Subject: Variance Request from Design Standards Section 14.2.3.e  
Jester Park Conservation Center  
Granger, Iowa  
IDNR Project No. S2014-0116

13.	Variance Rule:	567-64.2(9)c	
16. <u>Description of Variance Request:</u> Polk County Conservation is requesting variance from the Iowa Wastewater Facilities Design Standards Chapter 14 – Wastewater Treatment Works (Separation Requirements) for the construction of an on-site wastewater treatment mound system 320 feet from a lake.

RE: Wastewater Treatment System- Variance Request  
Polk County Conservation  
Jester Park Conservation Center

Treatment site

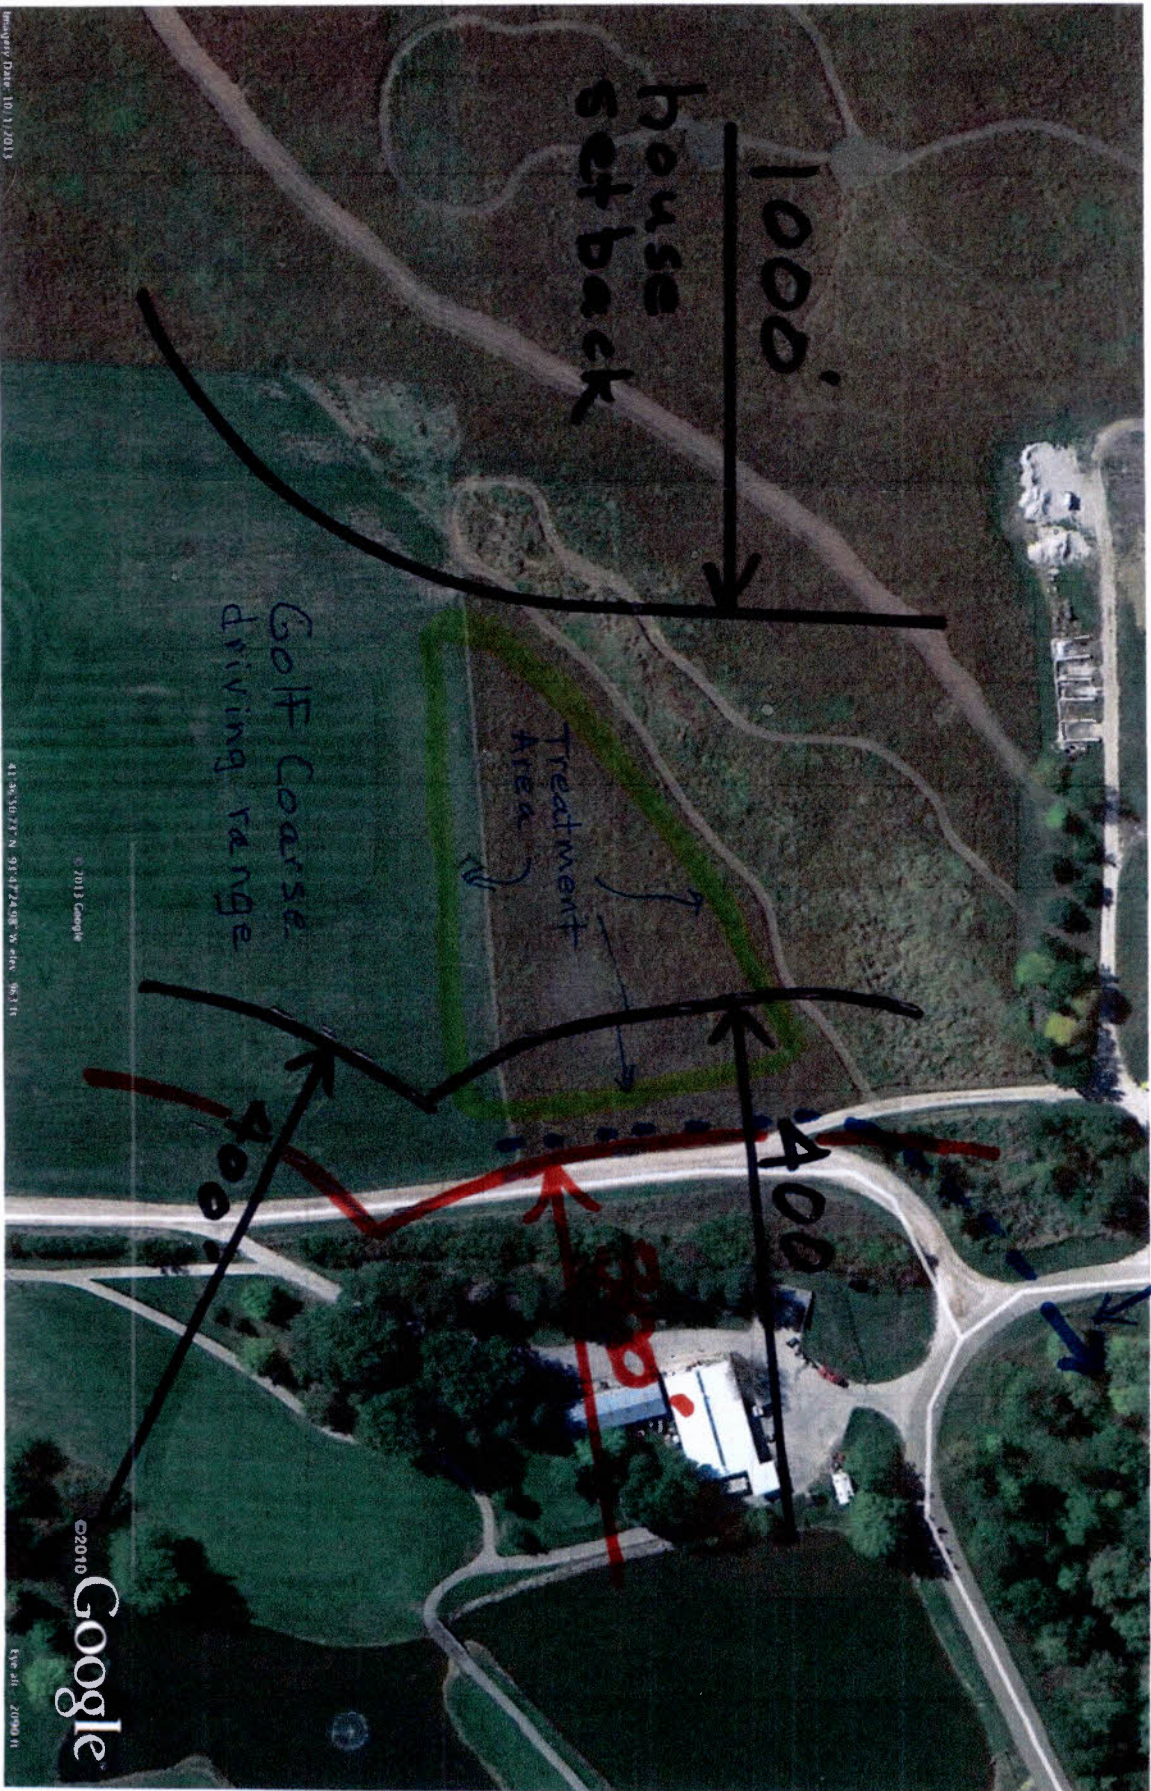
A site investigation by Field Office #5 requested on 1/24/14 and completed on 1/29/14 verified that the lake is located 320 feet from the closest part of the proposed soil dispersal system. Subsequent investigation has shown that lake is located on public property and that people fish in the lake. This activity creates a potential for public exposure to the water in the lake. Fishing is allowed at the site, and the park staff has observed people fishing the lake. Options for other locations and/or connection to existing systems may not have been adequately addressed.

Given the flow fluctuations, siting and operating issues, a soil based dispersal system is the best choice for this facility. The attached drawings show setbacks and other restrictions around the proposed dispersal site. This includes the 1,000-foot house setback, the golf course, and the 400-foot lake setback. The amount of surface area needed to disperse all of the estimated peak day flow would need to extend into the 400 foot setback of the lake to the east. We have determined that we will need to place a portion of the system within 320 to 400 feet of the lake. This amounts to about 30 percent of the treatment system.

Between the proposed site and lake is a large maintenance building as seen in the attached drawing. This building was cut into the hillside and will help divert any ground water to the north away from the lake.

There is a deep ravine northwest of the proposed treatment area. This ravine is also north of the lake. The ravine is about 350 feet from the treatment area. The depth of the ravine will act as a drain for ground water in the area and will create a ground water flow towards the ravine. This potential ground water flow direction would direct any ground water flow between the treatment area and the lake away from the lake.

We plan to install a tile line on the west side of the maintenance drive as shown on the attached drawing. The tile line will drain to the ravine and will reduce any ground water in the area. The tile line will be a minimum 10 feet away from the soil dispersal system. Chapter 69 has a minimum separation distance of 10 feet for tile lines.

Recommend variance disapproval.
